## Tweed Valley Hospital Hydrology Assessment

Reference No.  
Prepared for **Lendlease**  
15 August 2019

This report is confidential and is provided solely for the purposes of Lendlease as a review of the RBG Stormwater Management Plan basins and associated hydrology components. This report is provided pursuant to a Consultancy Agreement between SMEC Australia Pty Limited ("SMEC") and Lendlease, under which SMEC undertook to perform a specific and limited task for Lendlease. This report is strictly limited to the matters stated in it and subject to the various assumptions, qualifications and limitations in it and does not apply by implication to other matters. SMEC makes no representation that the scope, assumptions, qualifications and exclusions set out in this report will be suitable or sufficient for other purposes nor that the content of the report covers all matters which you may regard as material for your purposes.

Figure 3: 1% AEP Peak flood level impact map

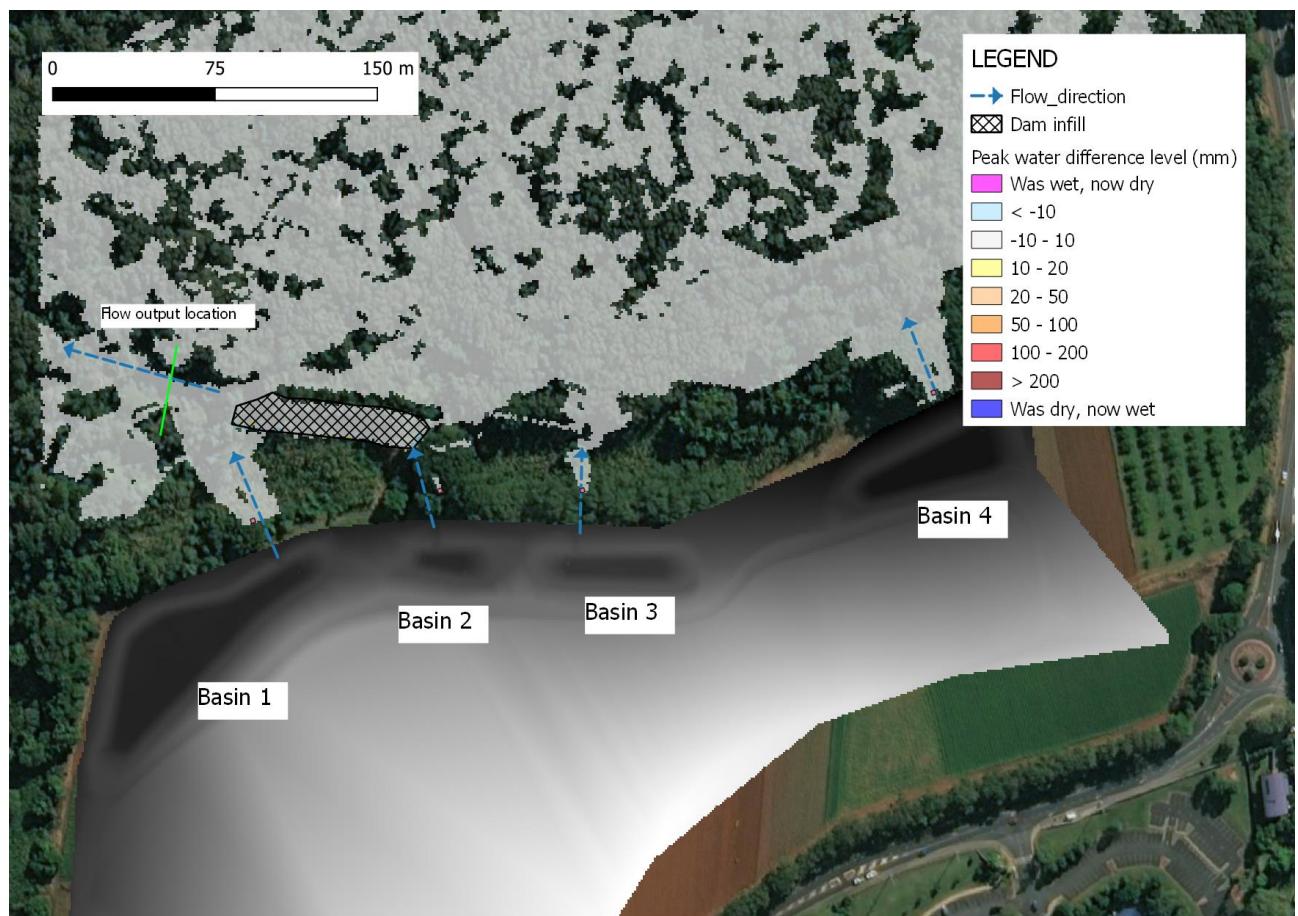
Figure 3 and 4 below show the difference in peak flood levels for the 4EY and 1% AEP event respectively. The grey shading indicates an impact of less than 10mm.

Figure 4: 4EY Peak flood level impact map

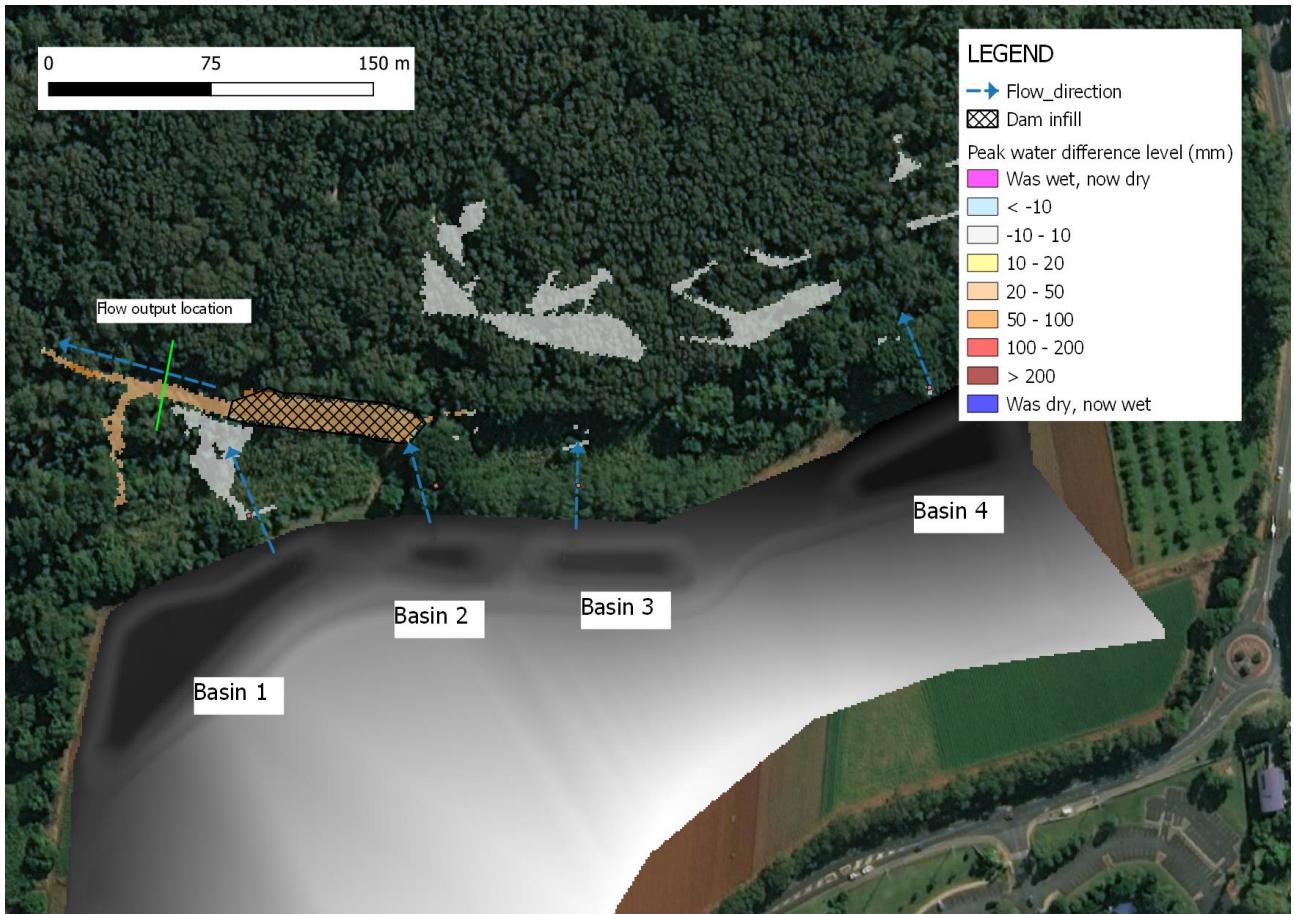
The impacts from the infilling are larger for the 4EY event where the loss of storage is more significant relative to the storm volume. For the 4EY event the flood levels increase approximately 50 mm at the outlet of the dam. It is noted there is no increase in inundation extent from the dam infilling for any design event.

Figure 5: 1% AEP dam outflow hydrograph

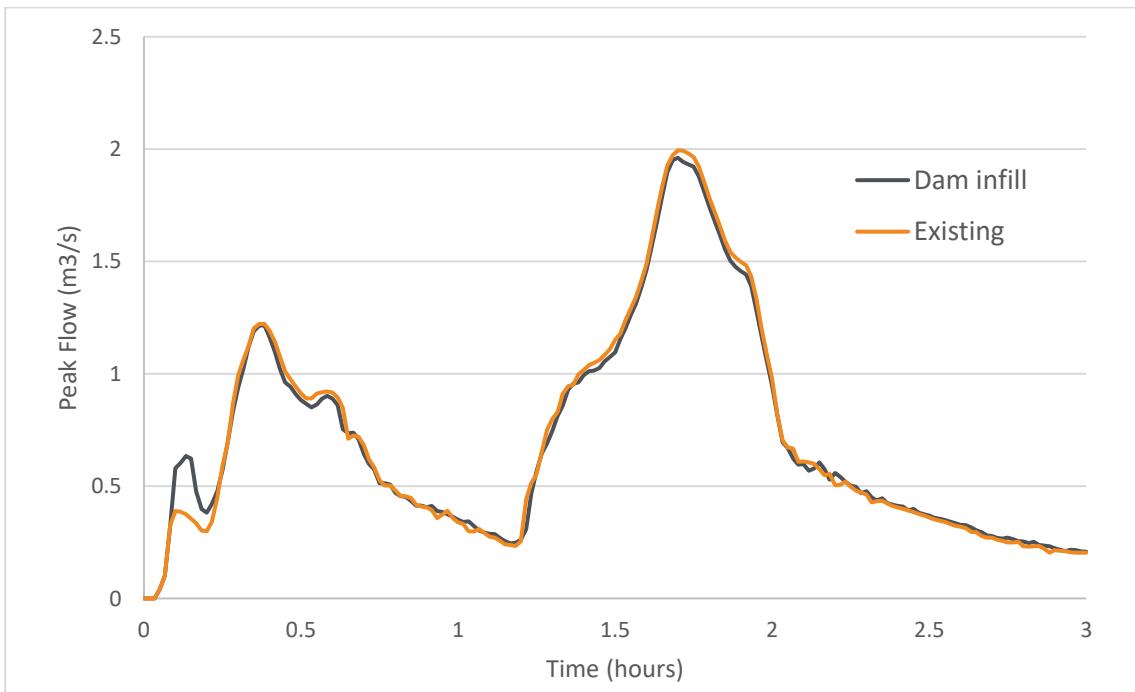
Figure-5 below shows the hydrograph plots for the outlet of the dam for the respective scenarios in the 1% AEP event. The loss of storage is seen early in the hydrograph although at the peak of the storm the loss of storage volume of the dam is negligible with peak discharges similar.

Figure 6: 4EY dam outflow hydrograph

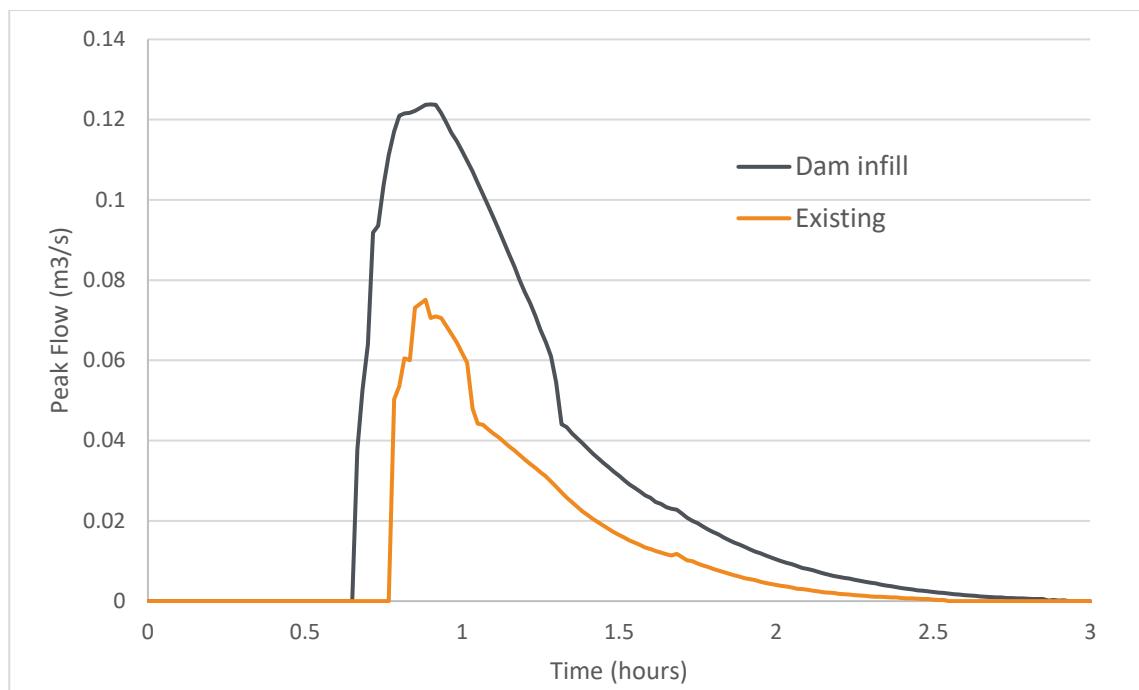
Figure 6 below shows hydrograph plots for the outlet of the dam for the respective scenarios in the 4EY event. The peak flow is only 0.125 m<sup>3</sup>/s, and when compared to the volume of the wetland with an area of 30.7ha is almost negligible.

The change in flows and volume has not resulted in any increased inundation extent and from a flooding perspective is considered to have no impact on the 1% and 20% AEP flood levels, and no material impact from more frequent events from a hydrology perspective. Ecological impact should be assessed for the frequent events
